ORIGINATION FORM

Proposed Revisions to a Standard Plans Index

Index Number: 646-001

Index Title: Aluminum Post and Pedestal Mounted
Pedestrian Detectors and Signals

LAST REVISION 11/01/21	DESCRIPTION:		FY 2023-24 STANDARD PLANS	ALUMINUM POST AND PEDESTAL MOUNTED PEDESTRIAN DETECTORS AND SIGNALS	INDEX	SHEET
					646-001	1 of 1

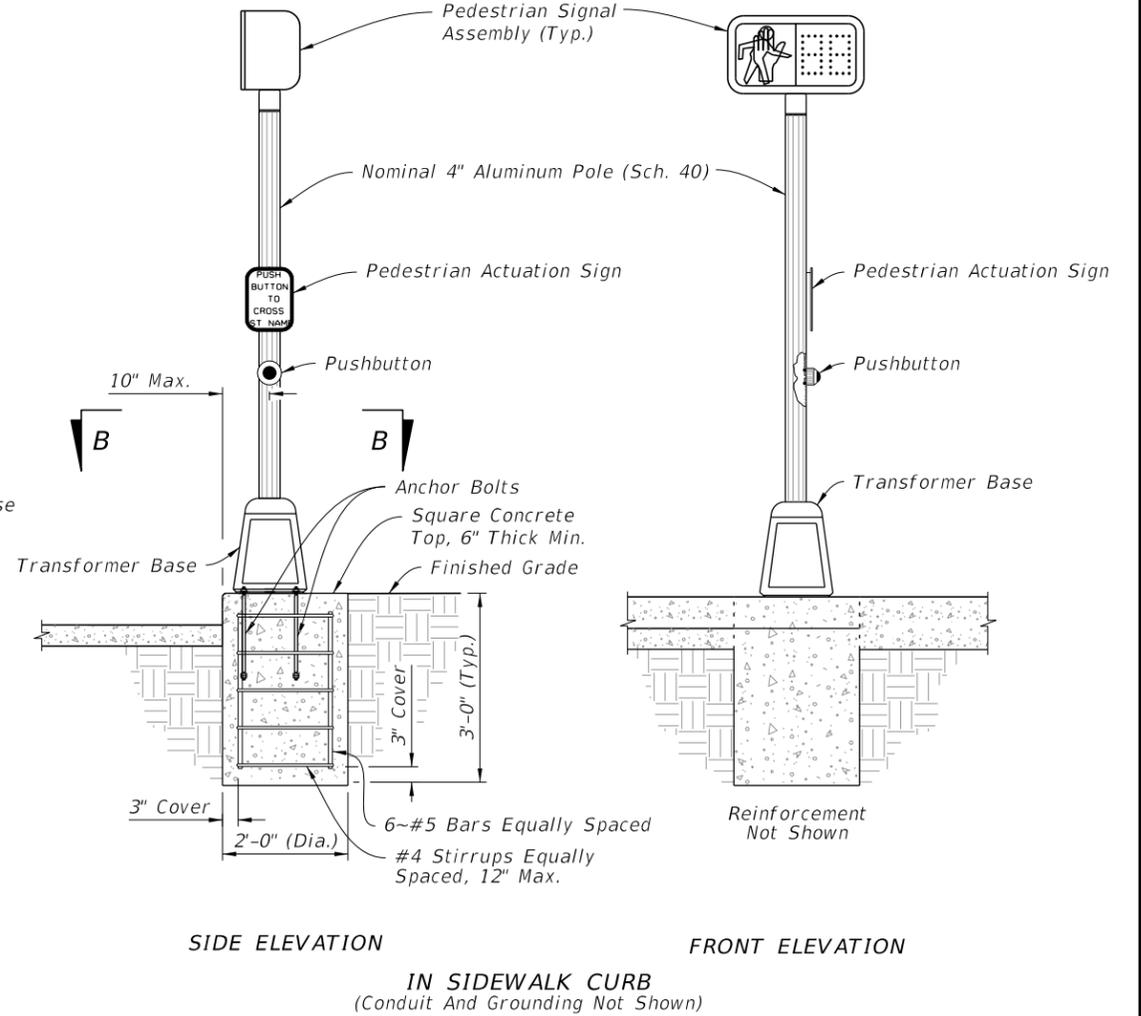
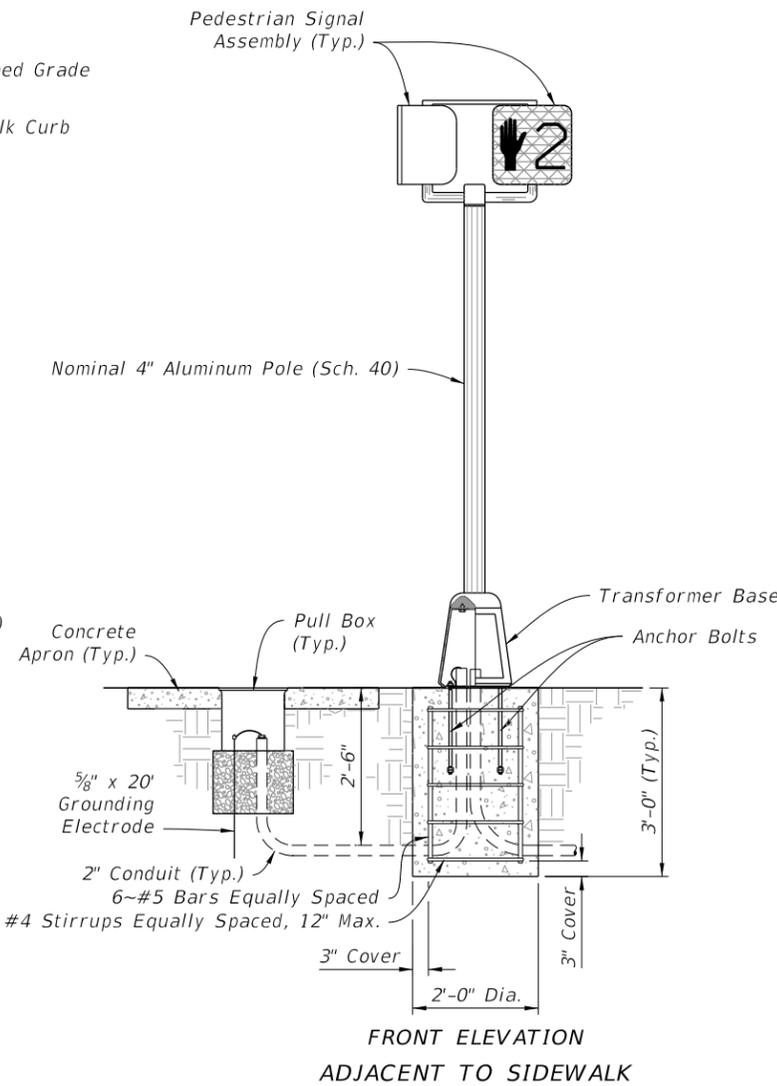
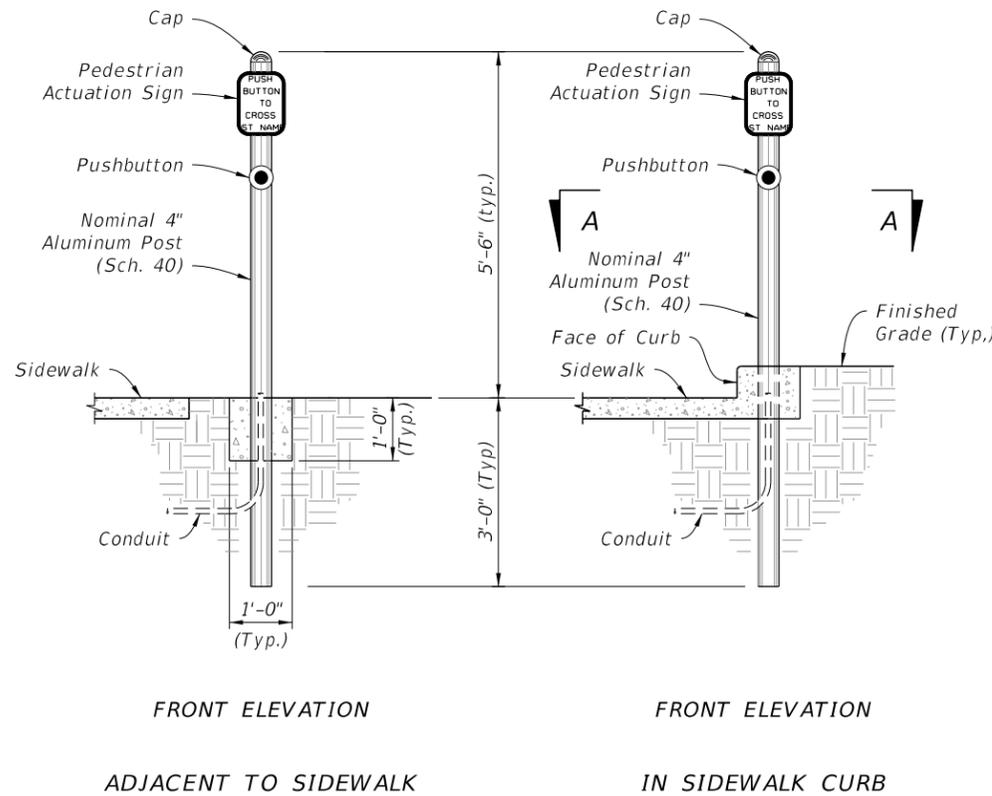
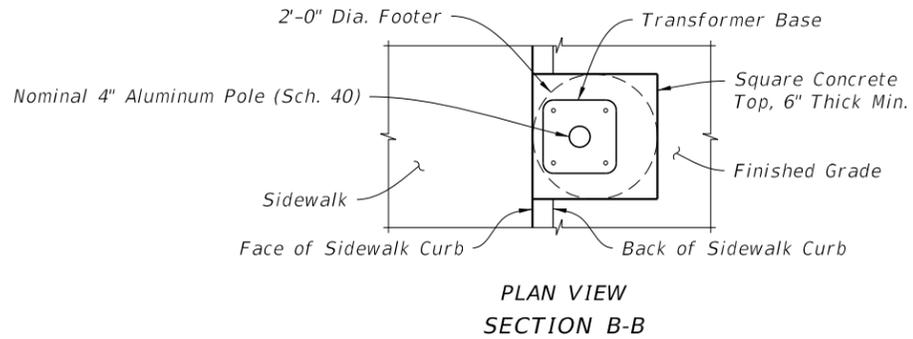
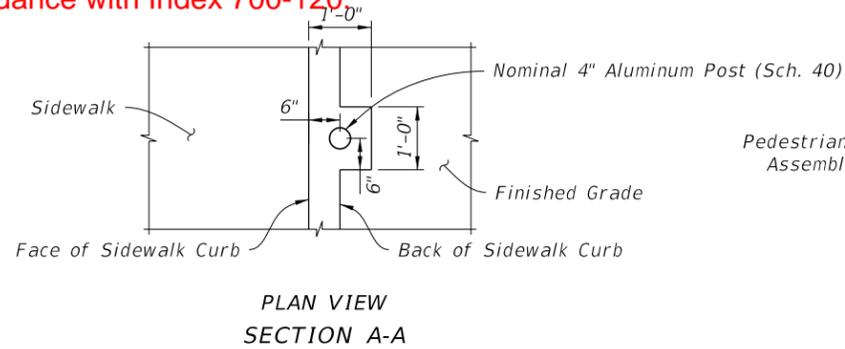
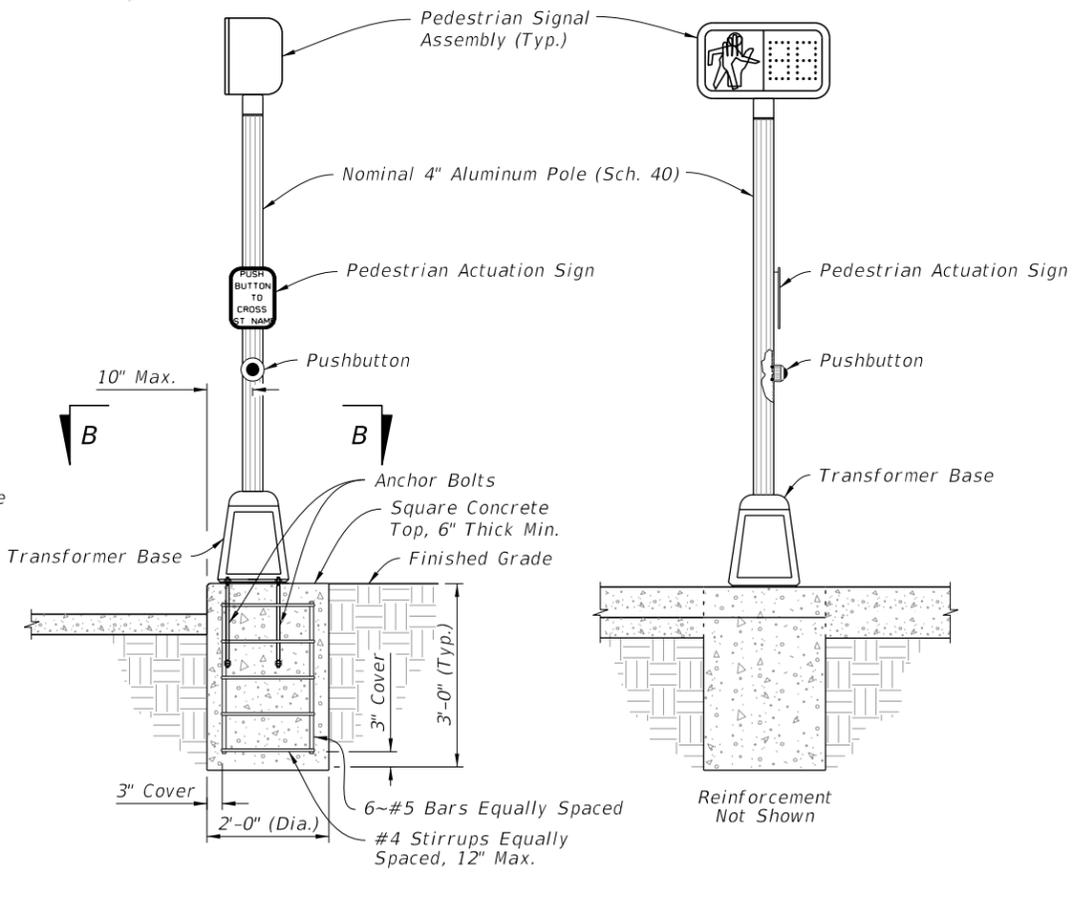
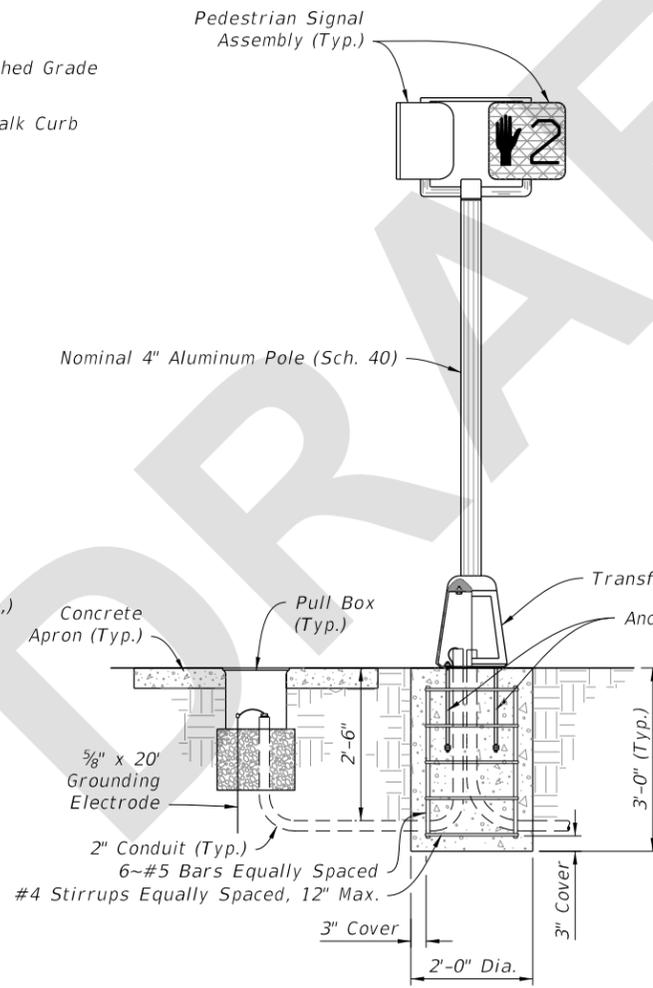
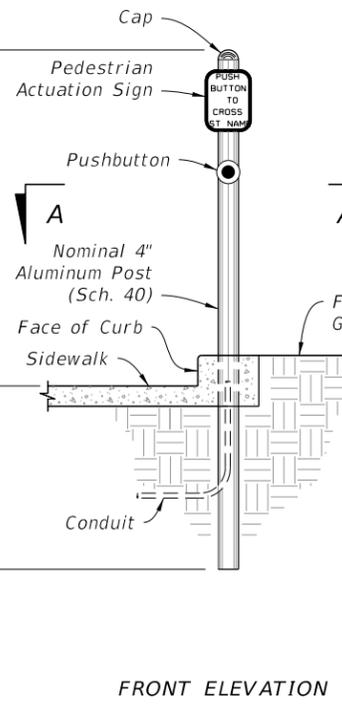
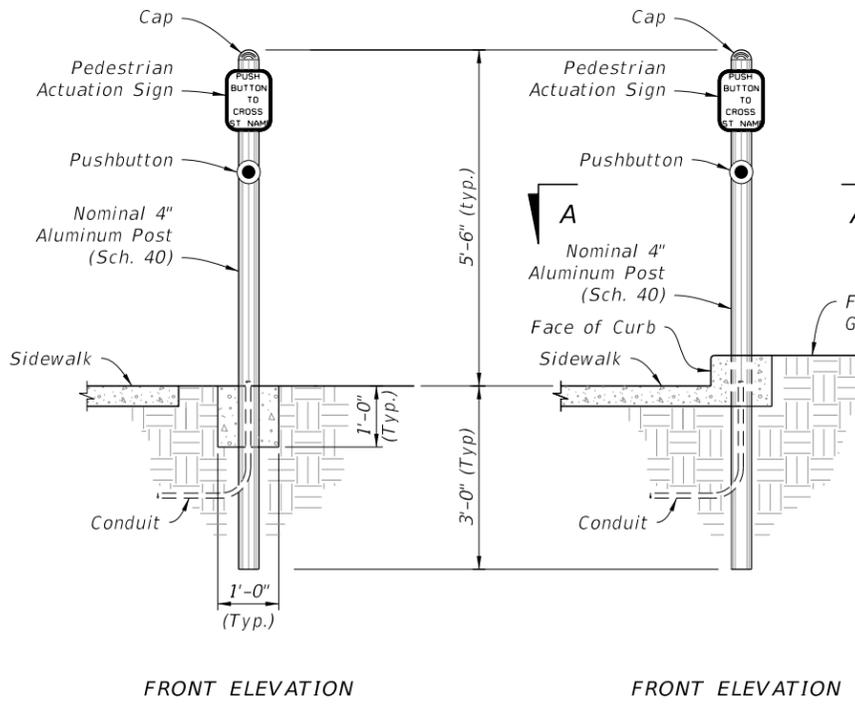
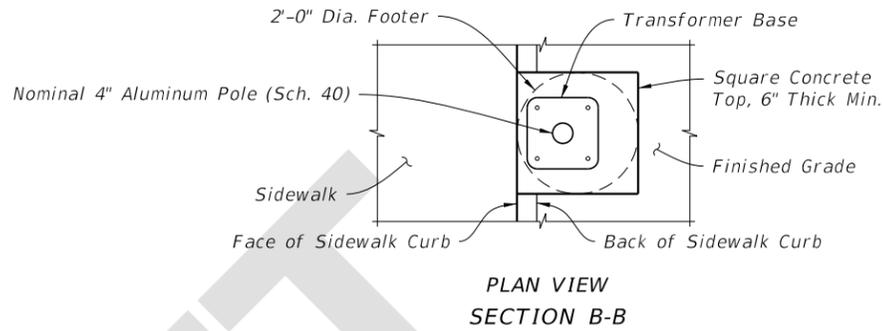
Added Note 6, "In lieu of footing design shown, a Spread Footing may be used in accordance with index 700-120."

Note 6 was added because of new spread footing design in Standard Plans Index 700-120.

6. In lieu of footing design shown, a Spread Footing may be used in accordance with Index 700-120.

1. Work this Index with Specification 646.
2. For Pedestrian Signals see Index 653-001.
3. For Pedestrian Detector Assembly (i.e., Pushbutton and Sign) details see Index 665-001.
4. Footing may be Cast-In-Place (C-I-P) or Precast.
5. As an alternative to the direct buried "Post Mounted" Pedestrian Detector Assembly shown below, the post may be installed on a transformer base. Use a transformer base included on the APL approved as an alternative to a "Post Mounted" assembly,
6. In lieu of footing design shown, a Spread Footing may be used in accordance with Index 700-120.
